9 Marvell Street, Byron Bay

Fire Engineering Preliminary Report

Appendix B Annotated Drawings – Fire Safety Preliminary Mark-up Drawings

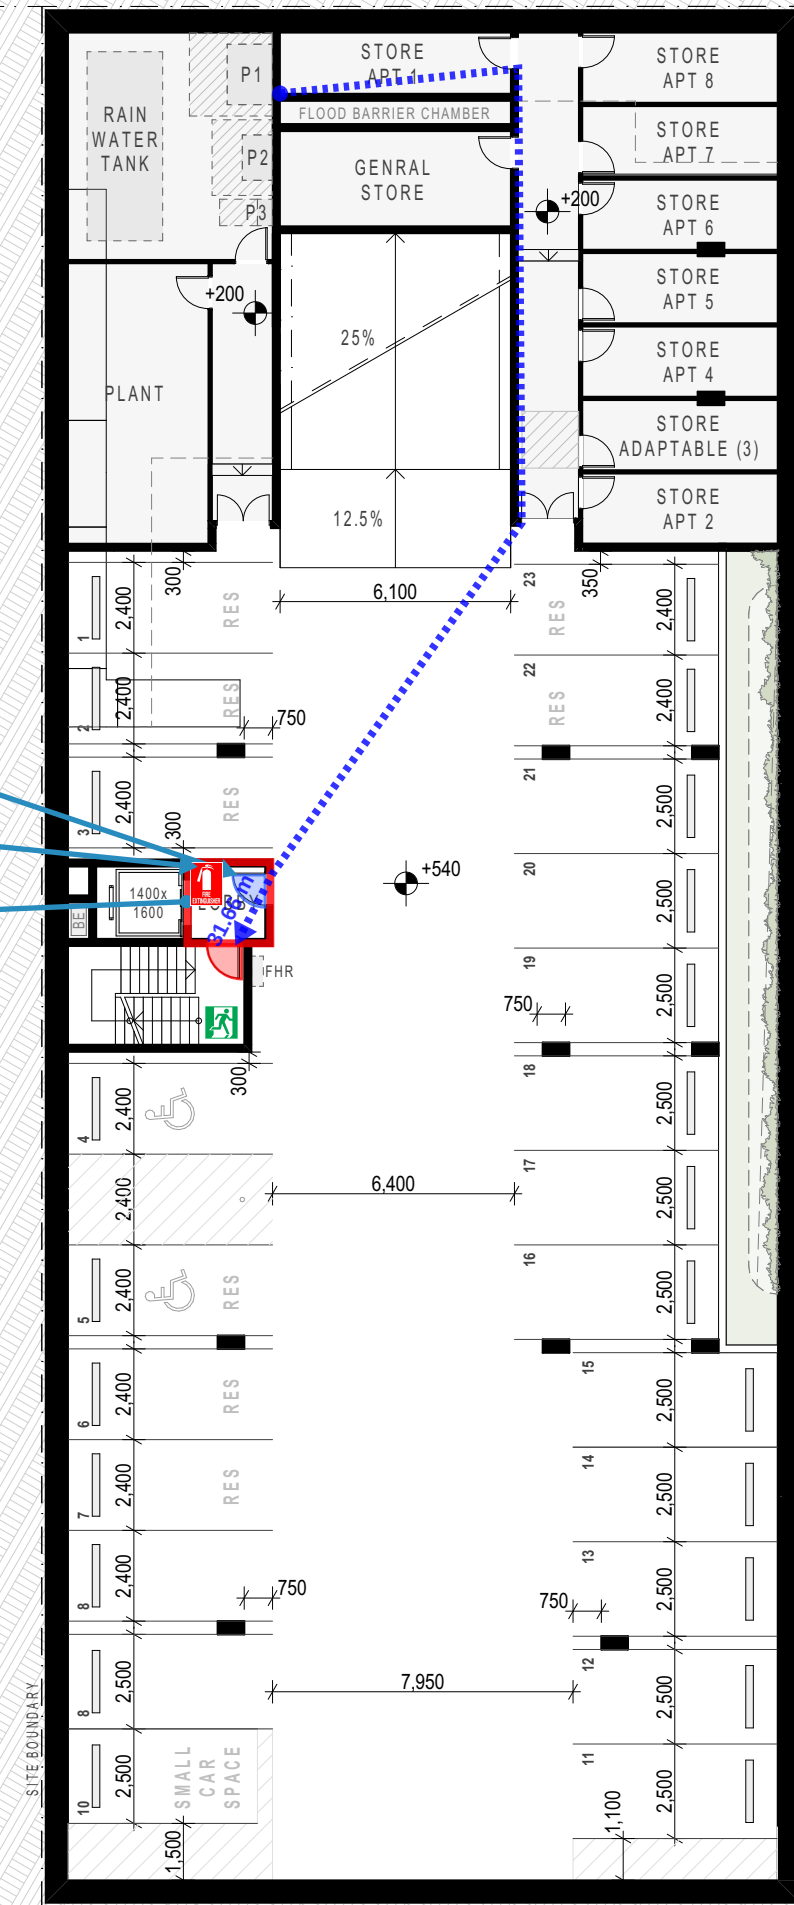
Door into the smoke-proof lobby will be a self-closing smoke door fitted with medium temperature smoke seals meeting the smoke leakage rates specified in AS6905 Pt. 2.4 parts (a) & (b).

Fire hose reels need not be provided within the smoke-proof lobby at Basement Level. A portable 2.5kg Dry Chemical Powder type fire extinguisher with a minimum rating of 3A:40B:E will be provided in lieu.

Smoke-proof lobby to be provided outside of the fire isolated exit stair

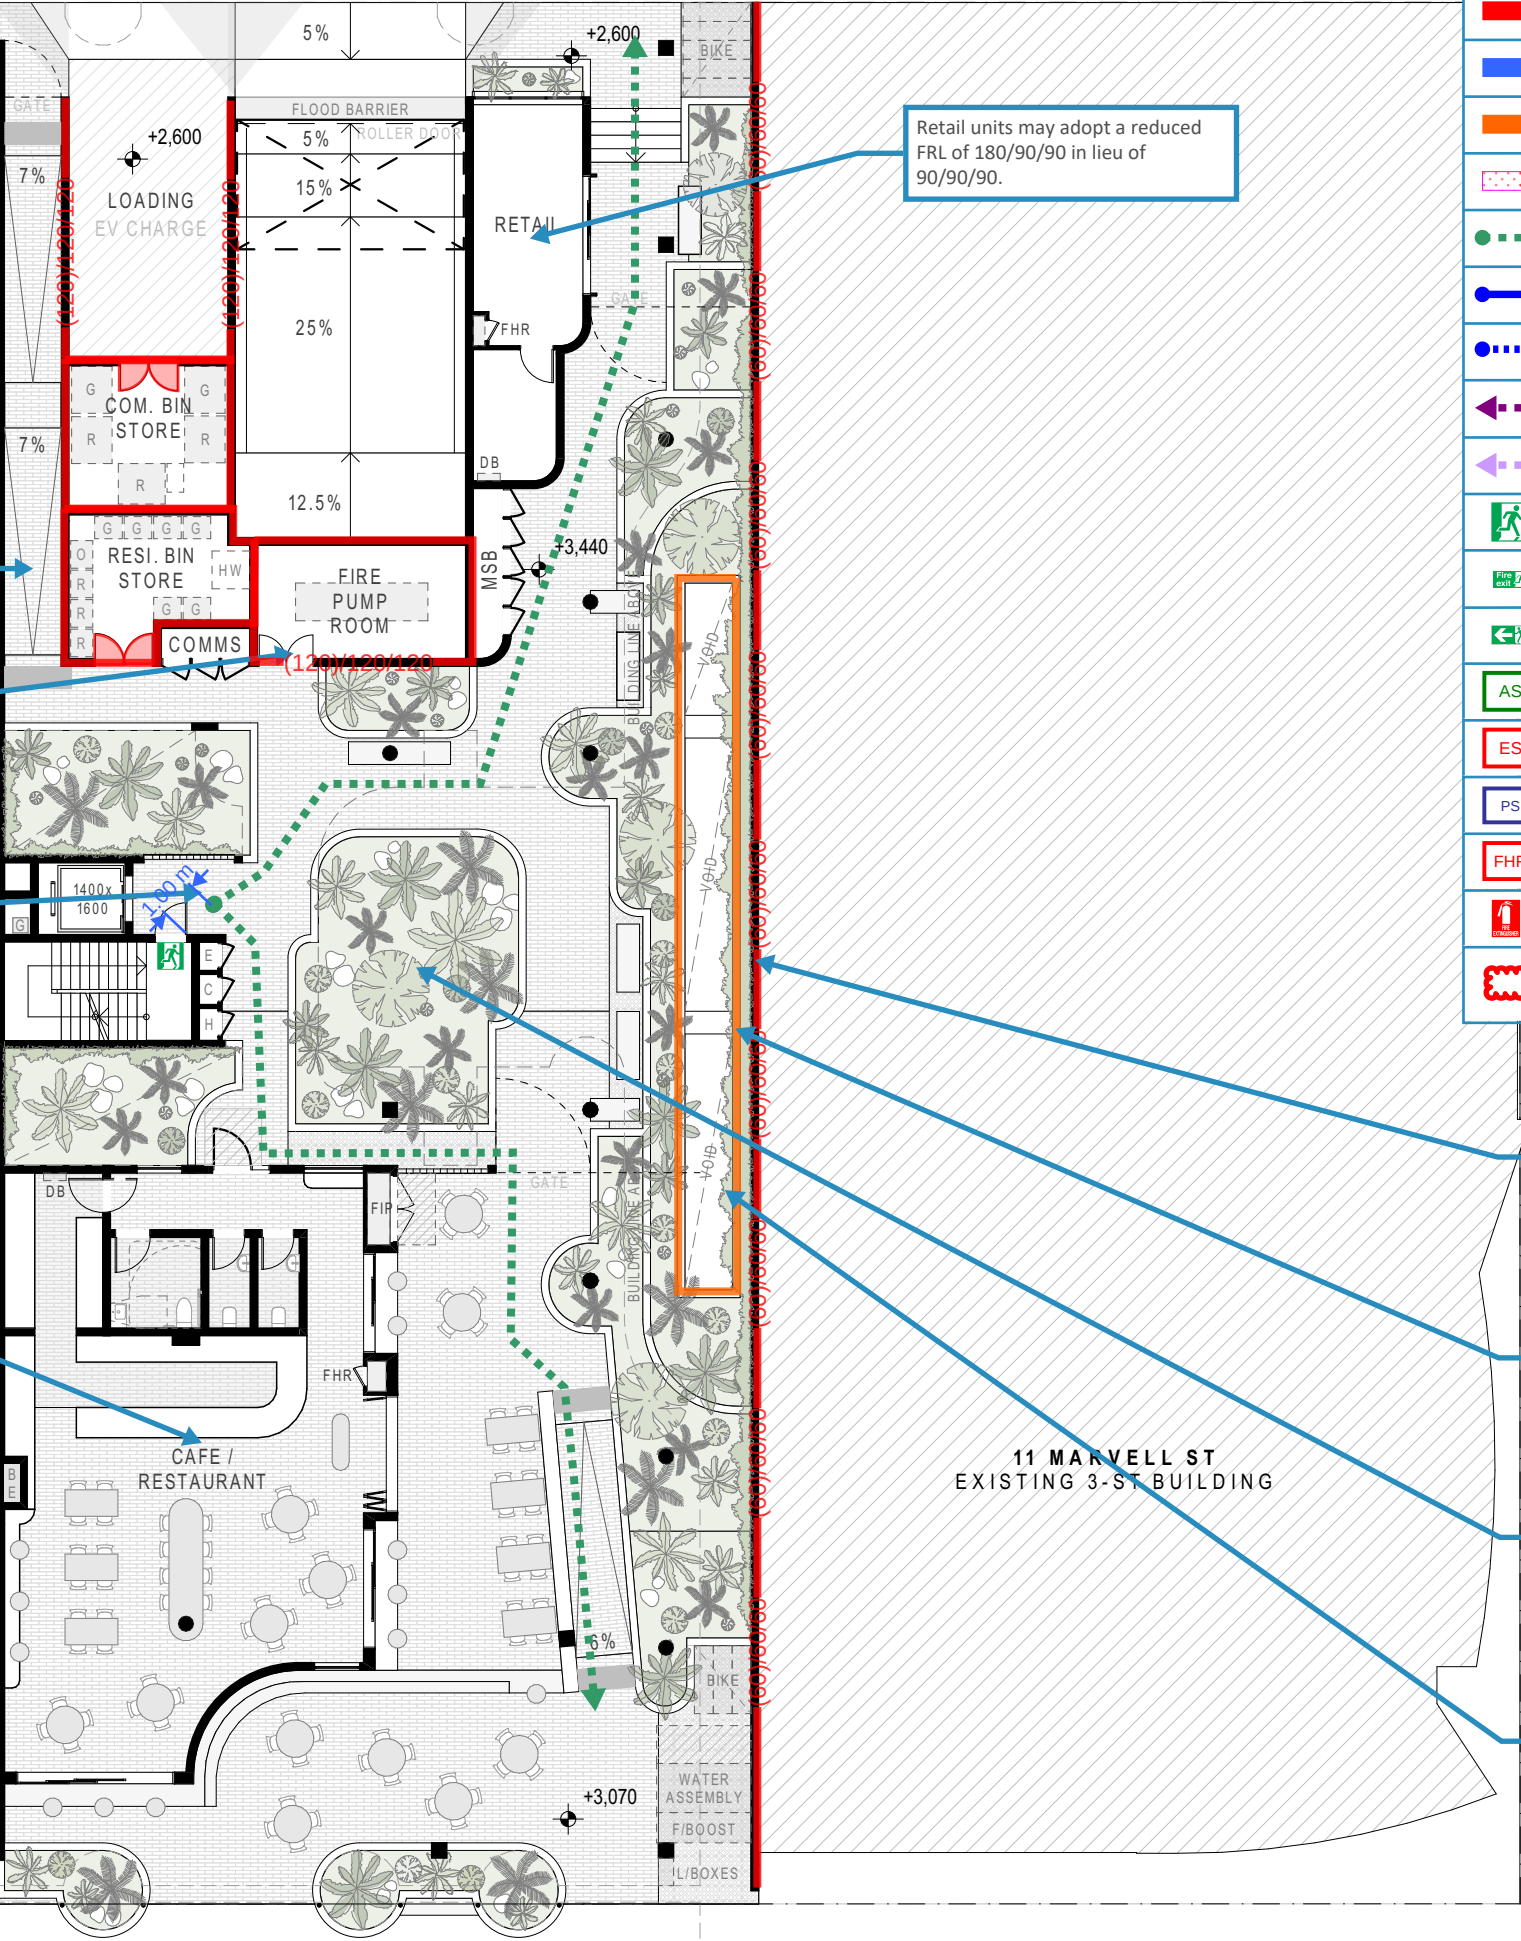
The walls bounding the loading bay, communal bin store, residential bin store and the fire pump room will be of construction that achieves at least a 120 minute FRL with respect to integrity and insulation criteria. The doors to the bin rooms are to be -/120/30 self-closing fire doors.

The pump room may be accessed from within the building as indicated on referenced architectural drawings in lieu of the location specified in AS2419.1.

Two paths of travel in opposite directions will be provided from within 1m of the fire isolated stair discharge door.

Retail units may adopt a reduced FRL of 180/90/90 in lieu of 90/90/90.

Retail units may adopt a reduced FRL of 180/90/90 in lieu of 90/90/90.

A fire rated wall will be provided on the eastern property boundary to achieve a FRL of (60/60/60). The wall will be of concrete/masonry construction and extend from the finished floor level of the Ground Floor to the finished floor level of the First Floor or above.

A balustrade will be provided around the void to Basement Level located at Ground Floor Level. The balustrade will extend to a minimum of 1.5m above the finished surface of the adjacent walkway and be of solid, non-combustible construction.

The degree of openness to the Ground Floor is to be maintained as indicated on the referenced architectural drawings. Light wells are not to be covered/enclosed (i.e. no shade coverings/awnings).

The framing structure for the vertical gardens will be constructed of metal fixed into the external wall. All elements of the vertical garden construction will be constructed in accordance with BCA Clause C2D14 with the exception of the living plant material that will grow on the metal frame.

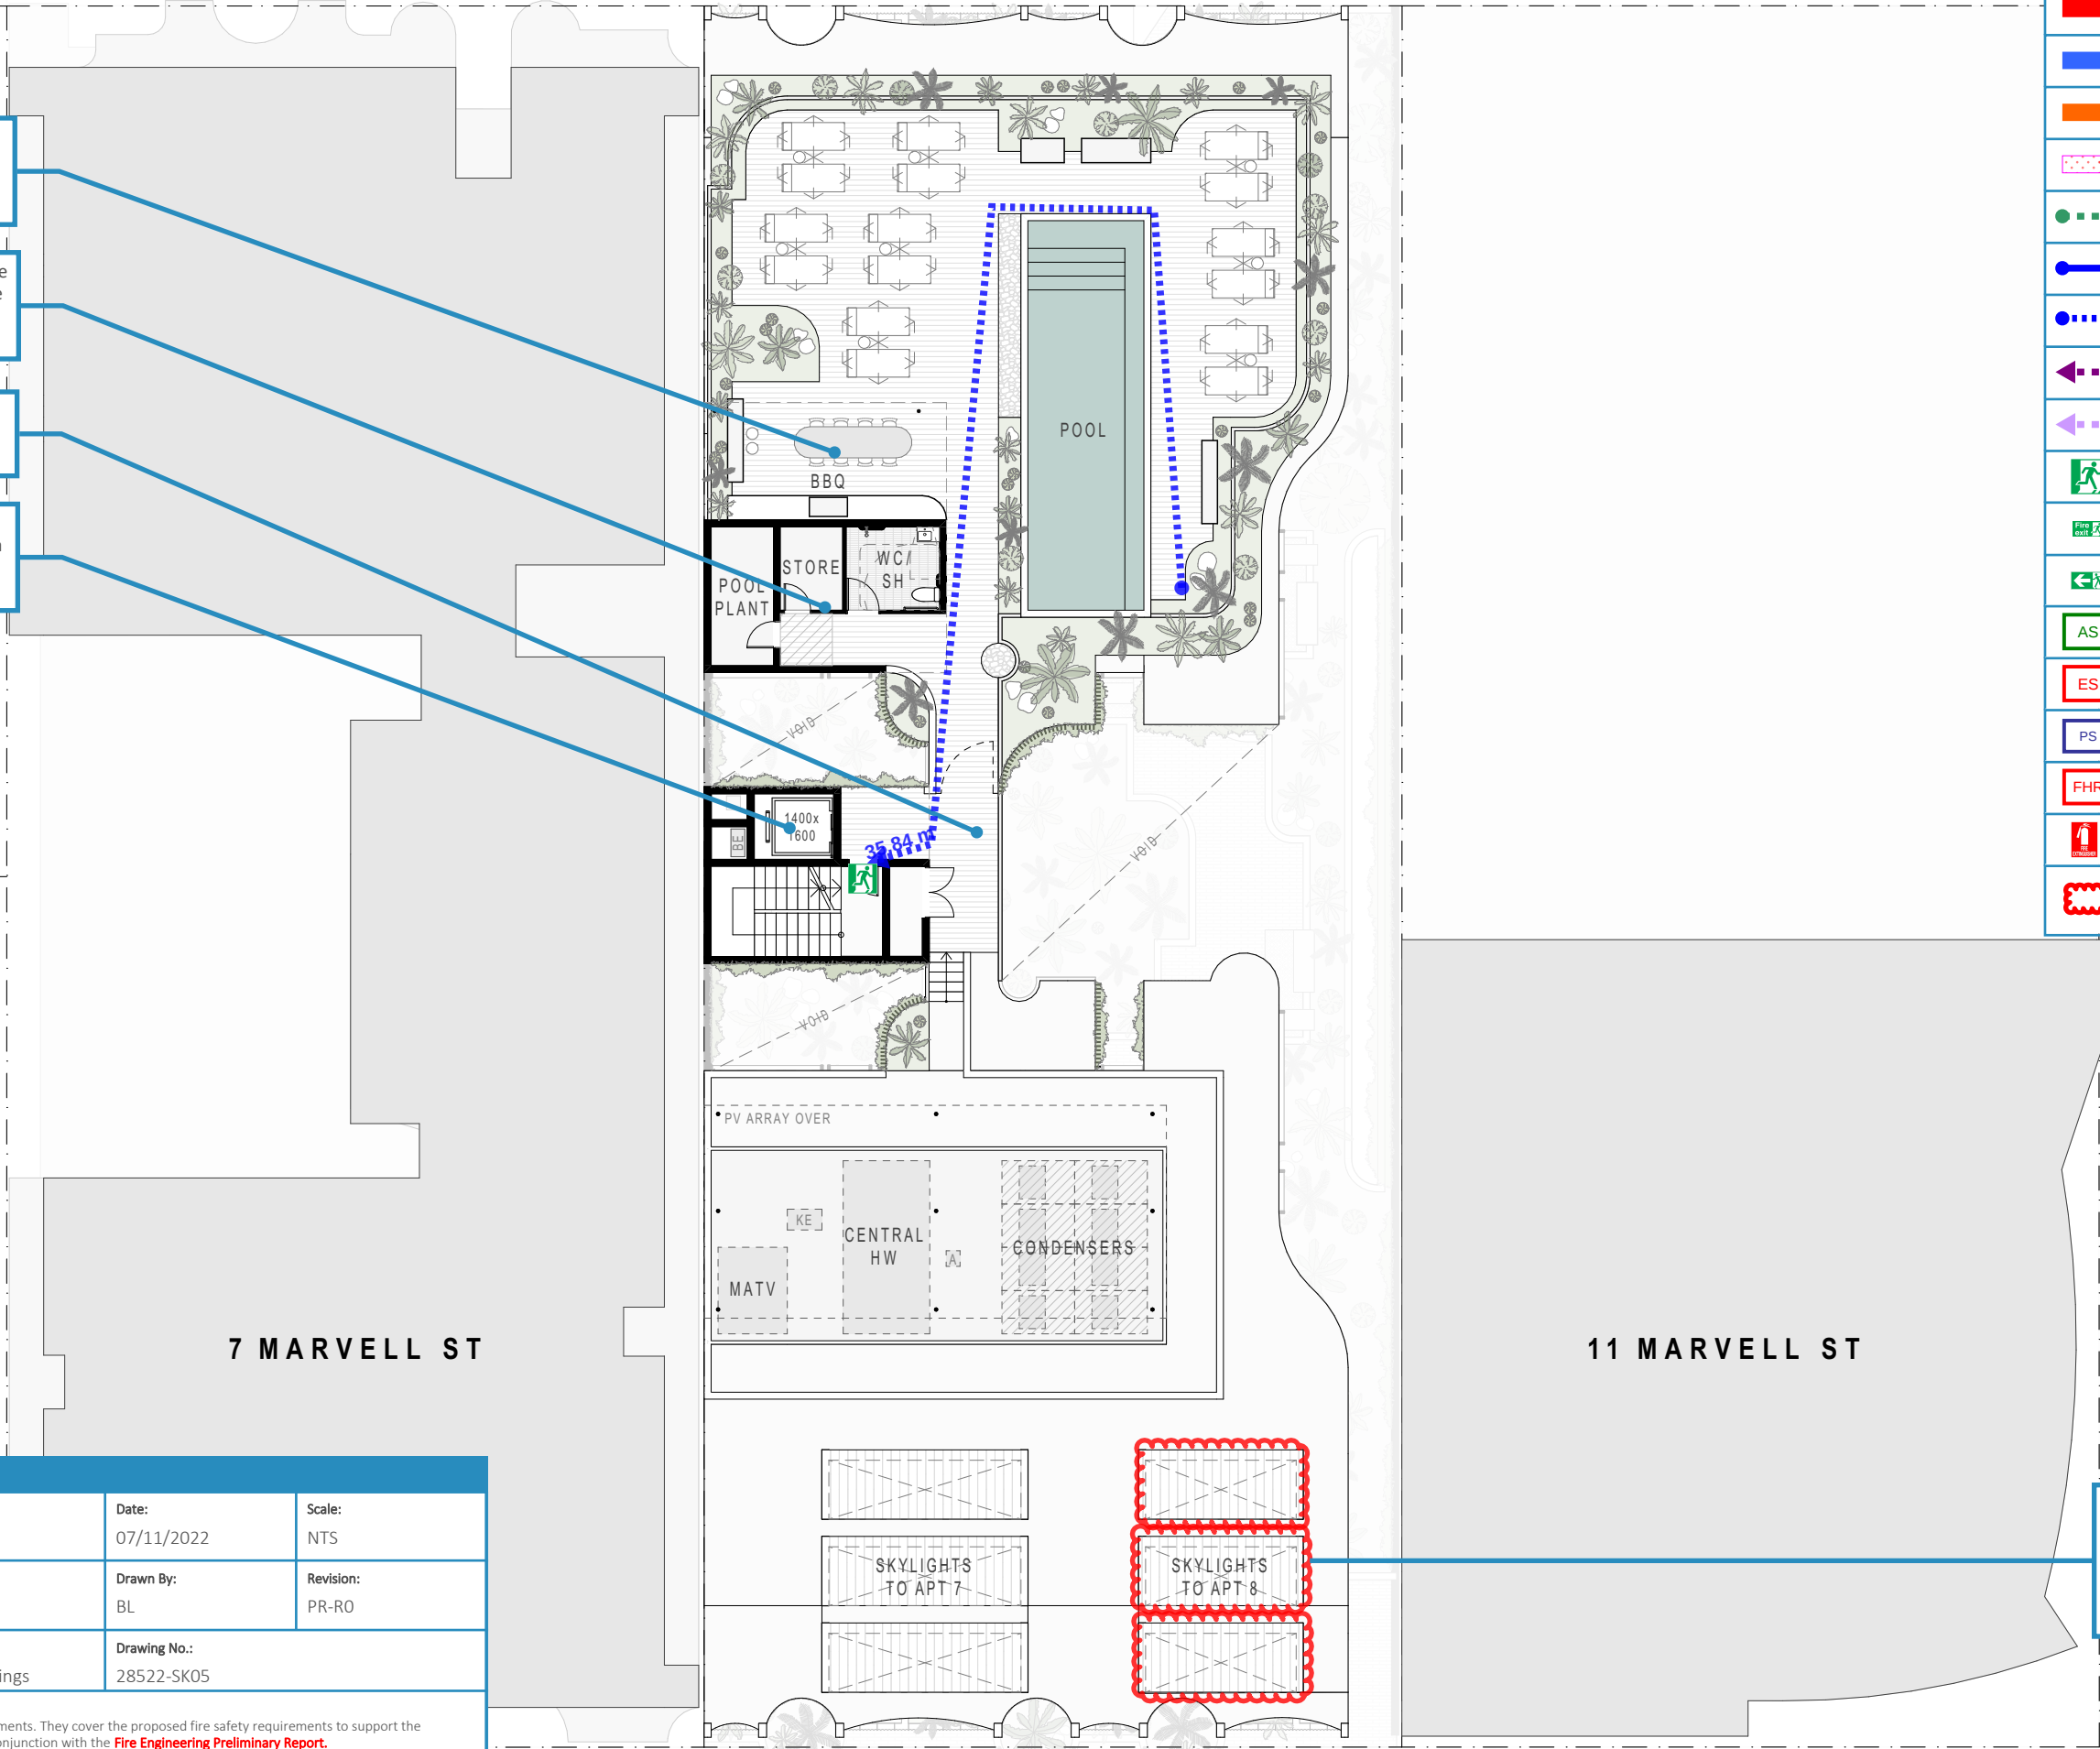
- The canopy/verandah above the BBQ area at the top level is to be constructed of non-combustible construction.
- Enclosed spaces at the top level are to be limited to the storeroom, the pool plant room and amenities compartment.
- Horn-type speakers will be provided to the outdoor spaces at the top level.
- A smoke / heat detector may be provided as appropriate in lieu of a sprinkler head at the top of the lift shaft.
